GAFFNEY BOARD OF PUBLIC WORKS

I-85 SEWER EXTENSION  
CONTRACT 1C – COLLECTIONS

ADDENDUM NO. 6

January 10, 2024

C-06-104A

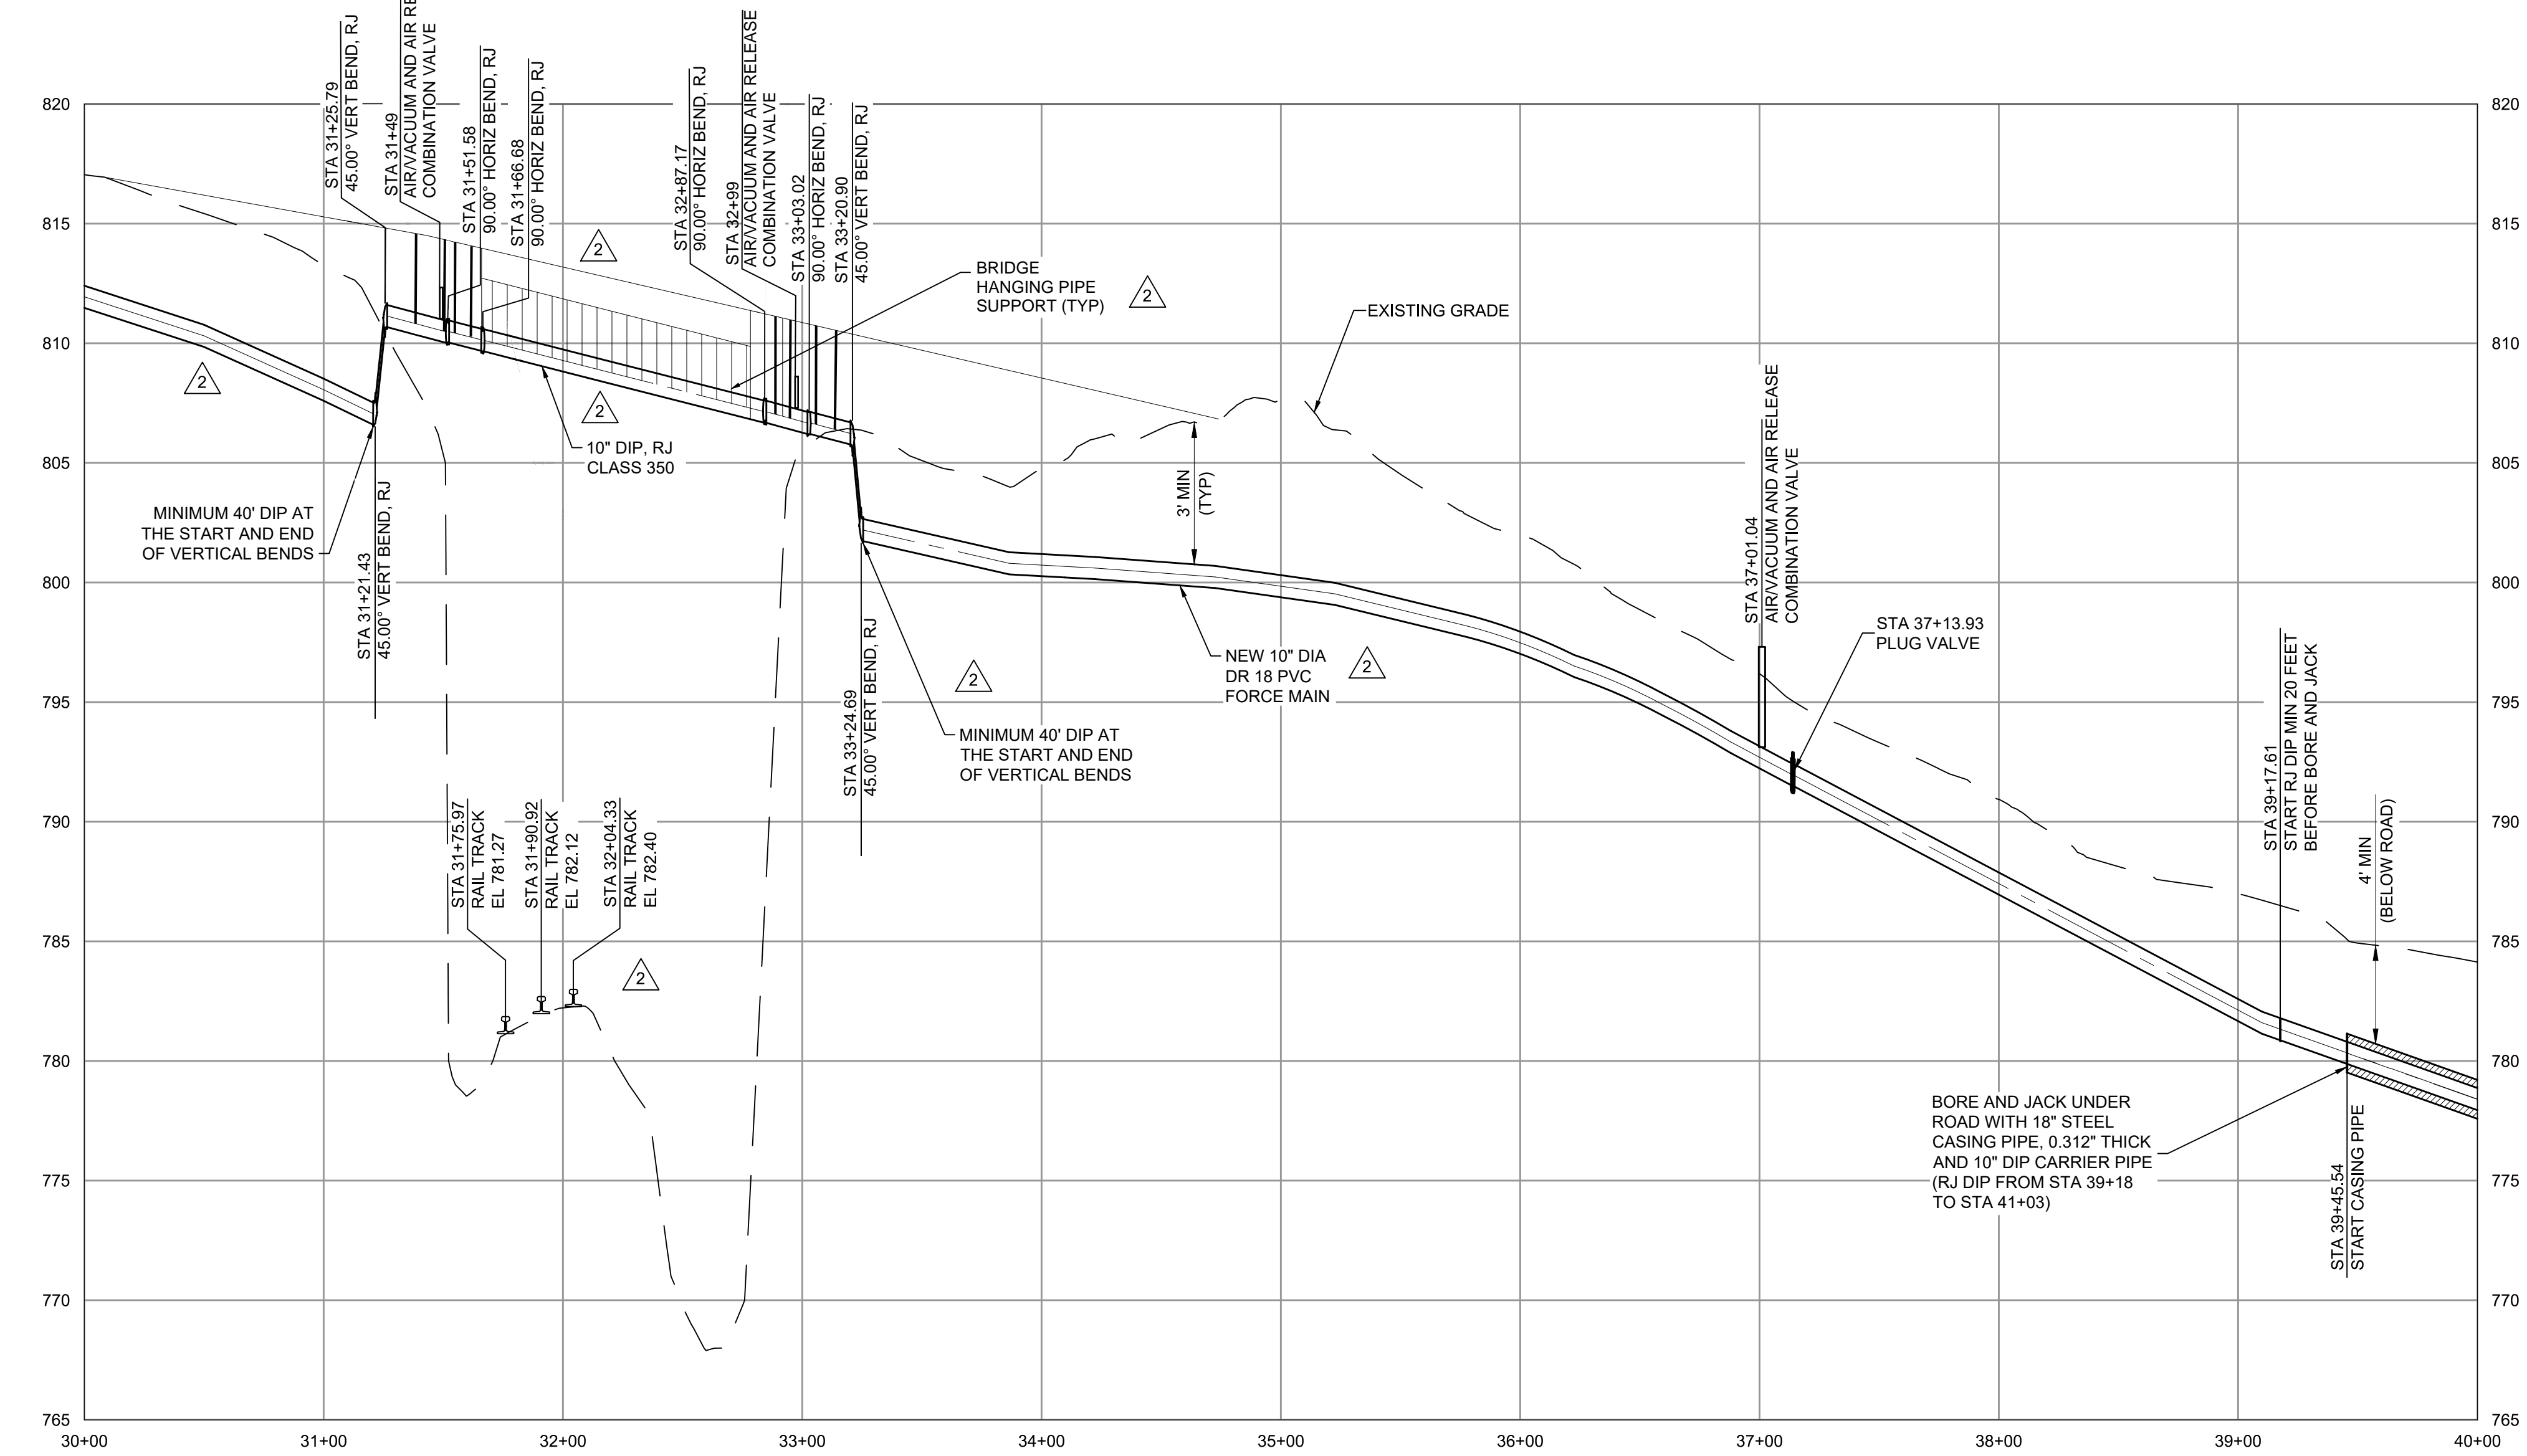
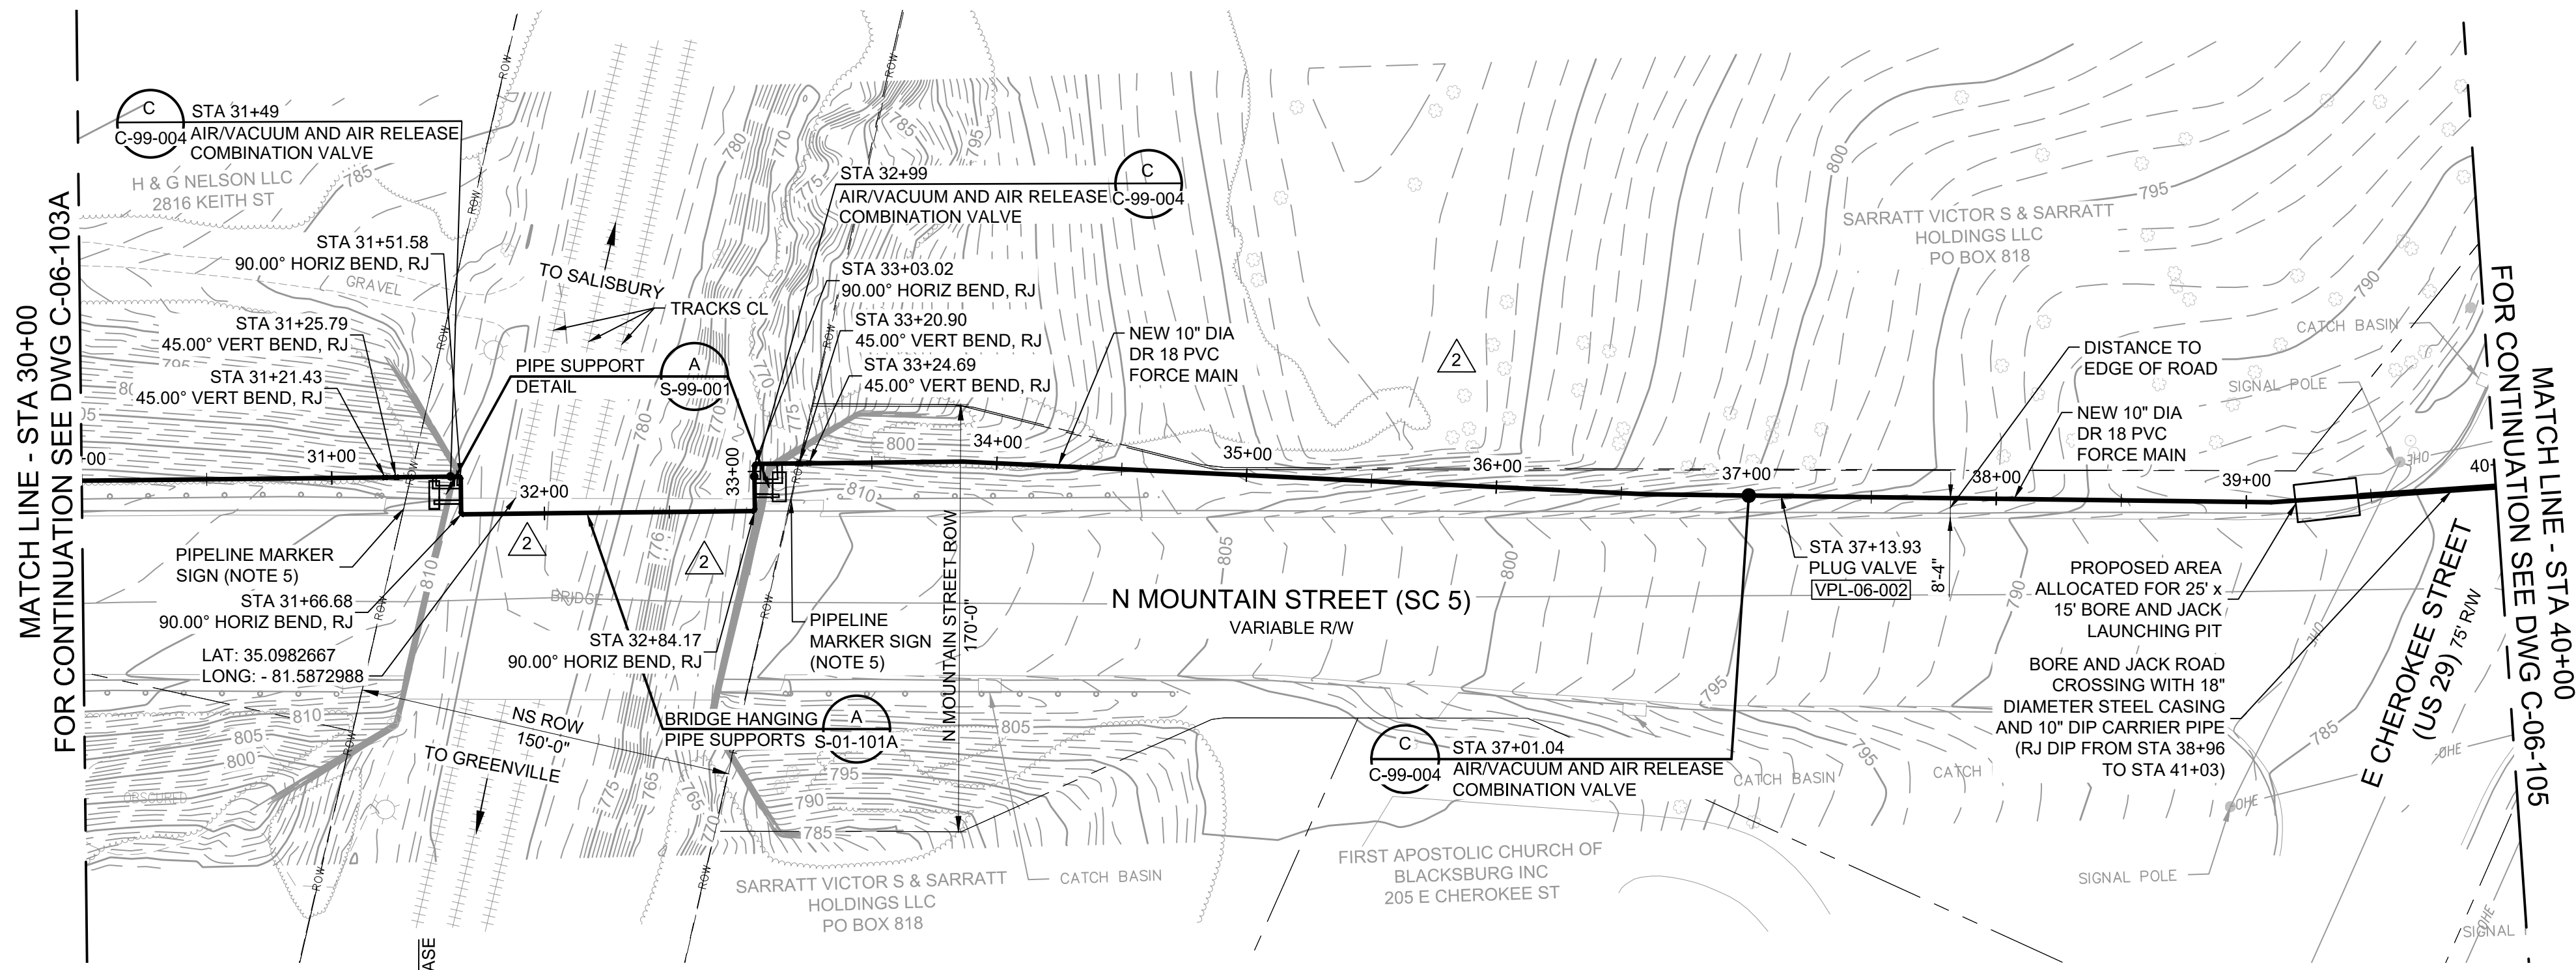
- i. Insert the attached new sheets C-06-103A and C-06-104A for Segment 6 Alternative 1 and the new sheet C-08-102A for Segment 8 Alternative 2 after sheet C-16-109.
- ii. Insert the attached new sheets S-00-001, S-01-101A, and S-01-102A for the Alternatives after sheet C-99-006.
